September 13, 2007

SRS-REG-2007-00021

**Update on Changes to Saltstone Flush Water Operation (U)**

Attachment 1

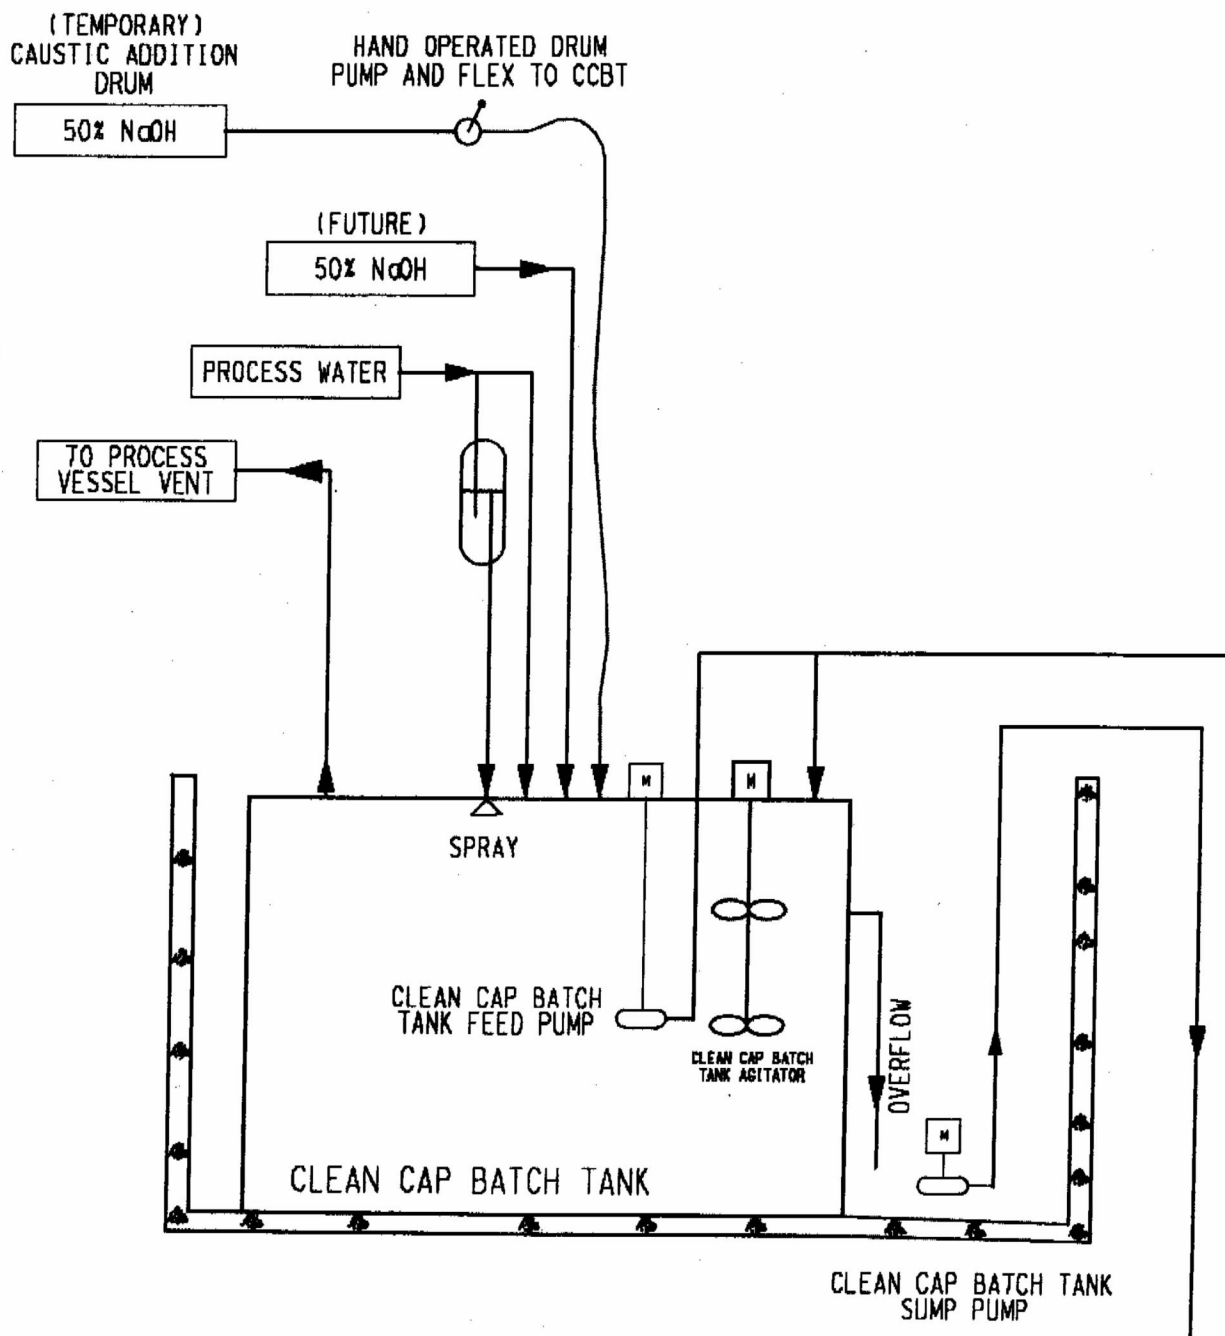
In the interim, as required, sodium hydroxide will be added to the CCBT using a normally blank-flanged opening on the CCBT tank top per the arrangement shown on Attachment 1.

### MAVRC/Vault #4 (Mixer at Vault Road Concept)

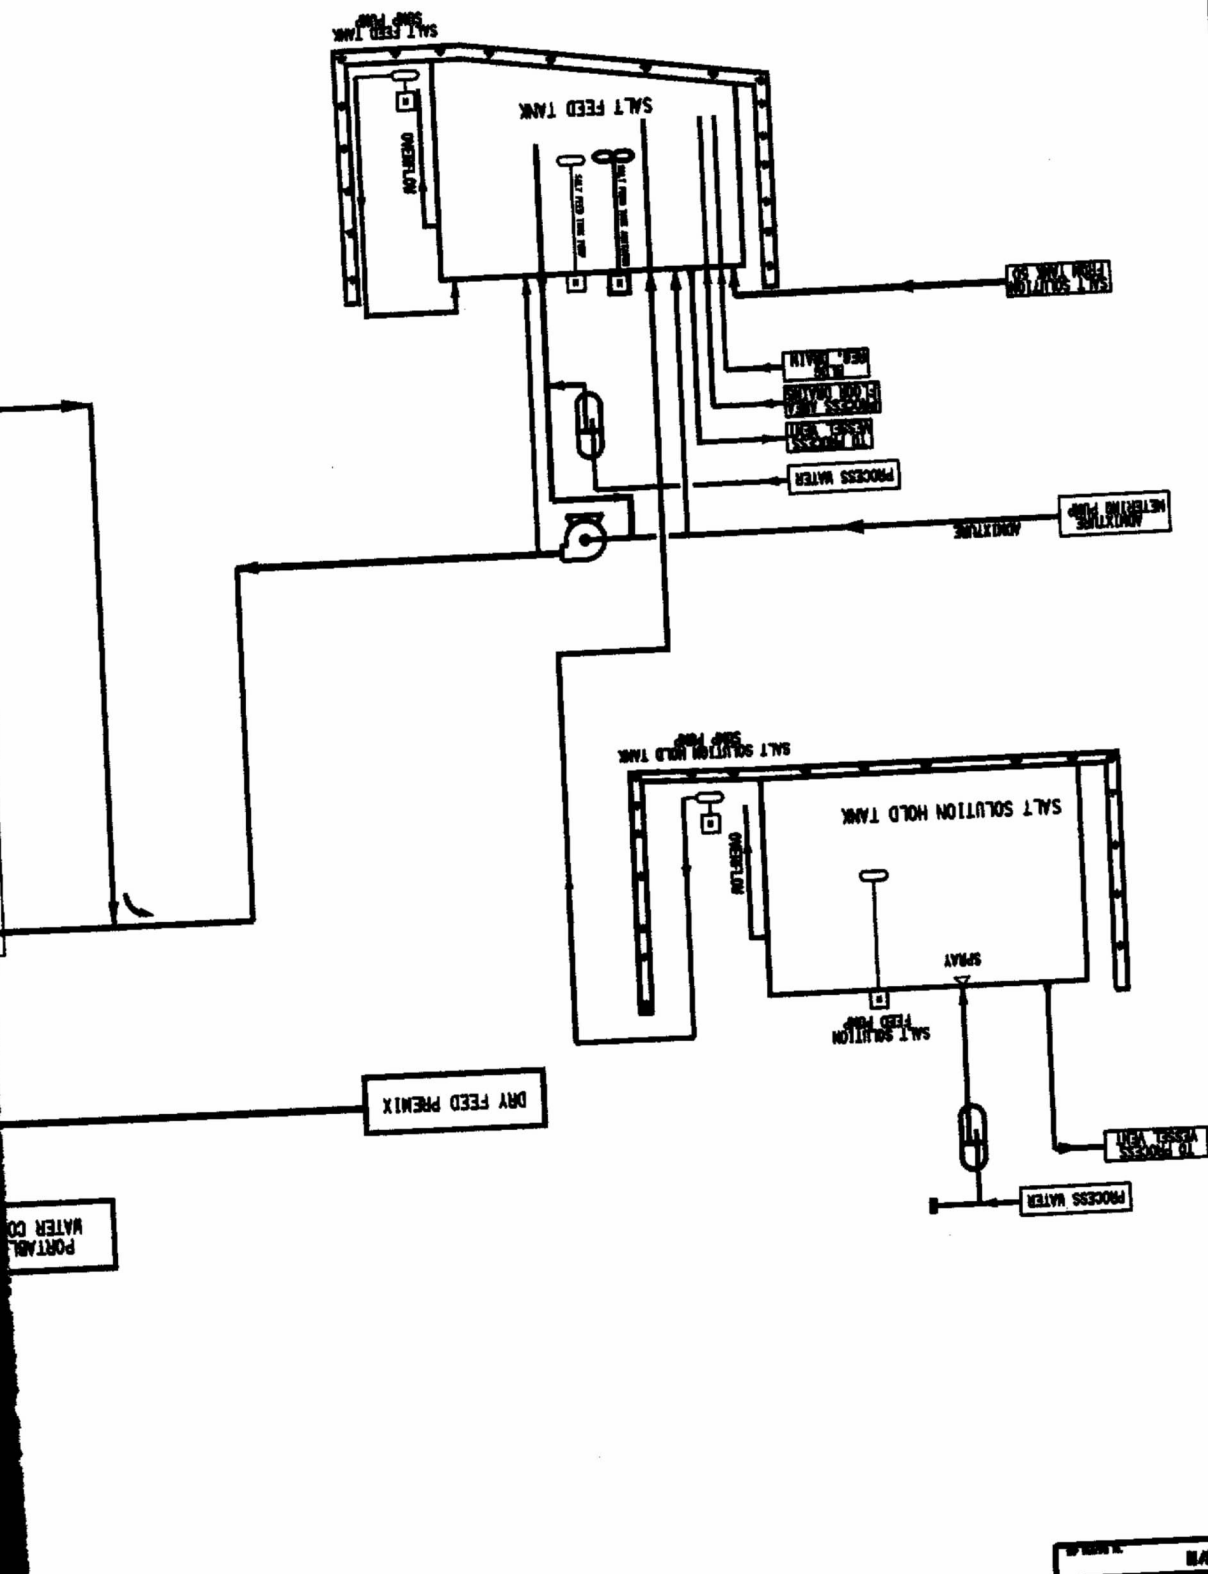
The SPF process modifications will be as follows: The mixer and associated piping, which are now located in Building 210-Z, will be relocated to an area near the SDF vaults. The current dry material system will be abandoned in place and replaced with a smaller system located adjacent to the mixer. The mixer, dry material equipment, and other ancillary equipment is to be movable so that it can be repositioned to other empty vaults or vault cells once filling operations are complete. This process arrangement is called the Mixer At Vault Road Concept (MAVRC) (see attachment #1). The repositioning of the MAVRC to empty vaults or vault cells, within the Z-Area boundary, will be administratively controlled by the SPF. Additional waste transfer and support equipment lines will be routed as needed. Additional Industrial Wastewater Permit modifications will not be submitted to the Department for these activities.

The current routing of the salt solution waste is from Tank 241-950H (50H) to the Salt Feed Tank (SFT) and then from the SFT to the mixer in the 210-Z process room. The modified routing will be from the SFT to the MAVRC. The transfer line will be constructed of a jacketed hard pipe for secondary containment. Leak detection capabilities will be installed on the transfer pipe to indicate a failure of the primary containment. The transfer line will be sloped such that it will drain back to the SFT when the SPF is not operating. The transfer line will consist of below and above ground sections. Appropriate radiation shielding will be installed on the transfer line.

In order to maintain personnel exposure ALARA, the bleed and process water will be pumped back to the SPF through a hard piped transfer line from the SDF - Vault#4 to the Salt Feed Tank. The bleed and process water will be added to the salt solution and will be processed into grout. The bleed and process water drain pump will be housed in a dedicated dike.
